Constellation
Heritage
4700 Models
> 4800 Models

**Western Star
Service Bulletin**

General Information

Fig. 1, Air Tank and Bracket Installation

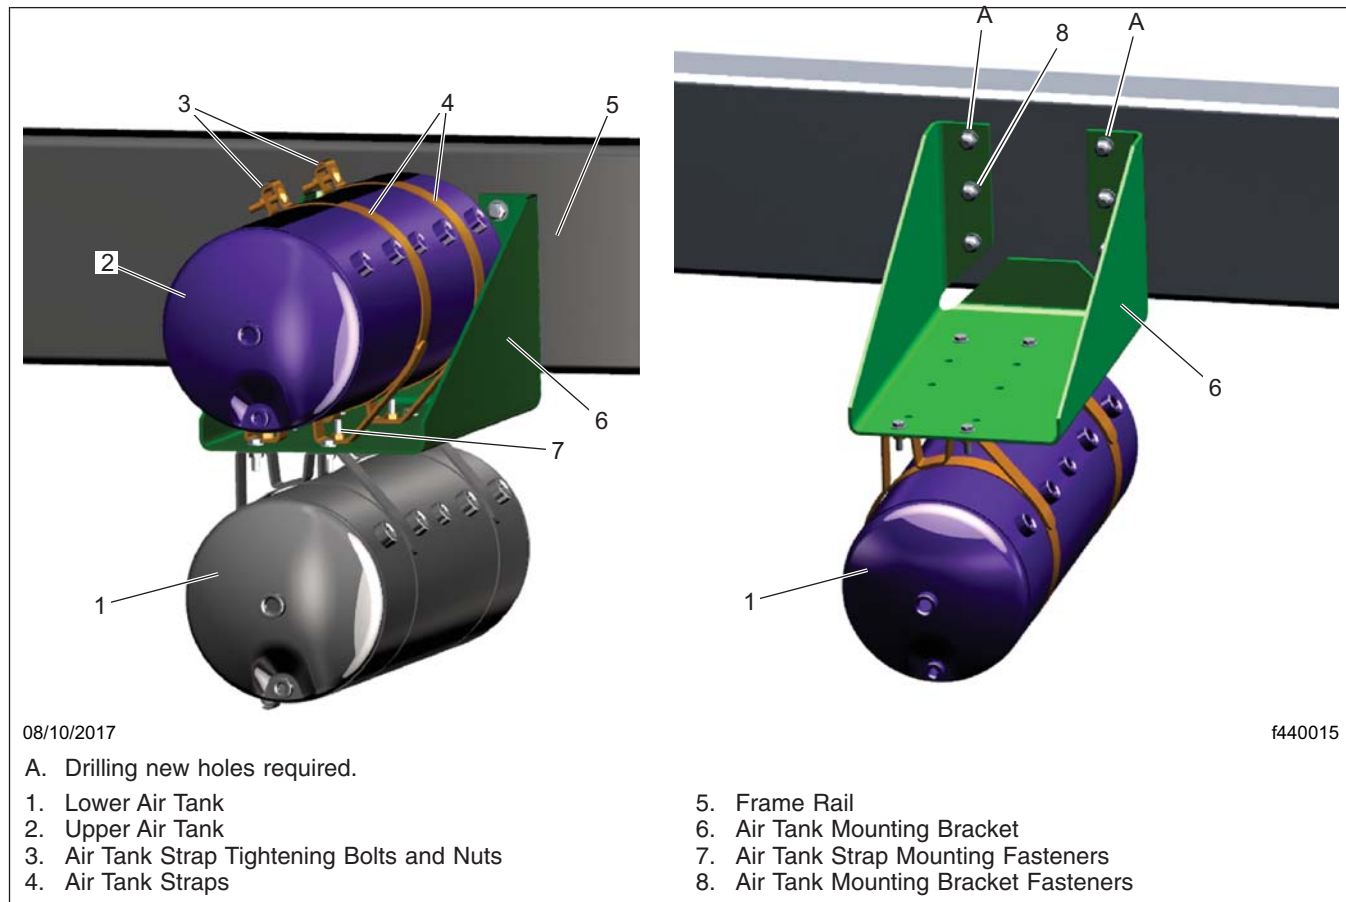
The Western Star perpendicular air tank bracket (part number WWS 71103-3445) has been discontinued and replaced with a new design (part number 12-27543-000). When upgrading to the new perpendicular air tank bracket, new air tank mounting straps and hardware are also required. Two additional holes must be back drilled through the frame rail.

1. Align the lower four holes of the new bracket with the existing frame holes and install the four mounting bolts. Hand tighten the four bolts.
2. Mark the two top holes that need to be drilled.
3. Remove the four mounting bolts and the new bracket.
4. Verify that no lines or wiring harnesses are in the way.
5. Using a 13.5 mm (17/32 inch) bit, drill the top two holes through the frame rail.
6. Install the bracket and hand tighten the six mounting bolts. Tighten the fasteners 64 lbf·ft (87 N·m).

7. Install both upper tank strap brackets onto the mounting bracket. Tighten the fasteners 28 lbf·ft (38 N·m).
8. Install both lower tank strap brackets onto the mounting bracket. Tighten the fasteners 28 lbf·ft (38 N·m).
9. Install the upper tank onto the mounting bracket. Tighten the reaction joint clamp bolts 26 lbf·ft (35 N·m).
10. Install the lower tank onto the mounting bracket. Tighten the reaction joint clamp bolts 26 lbf·ft (35 N·m).
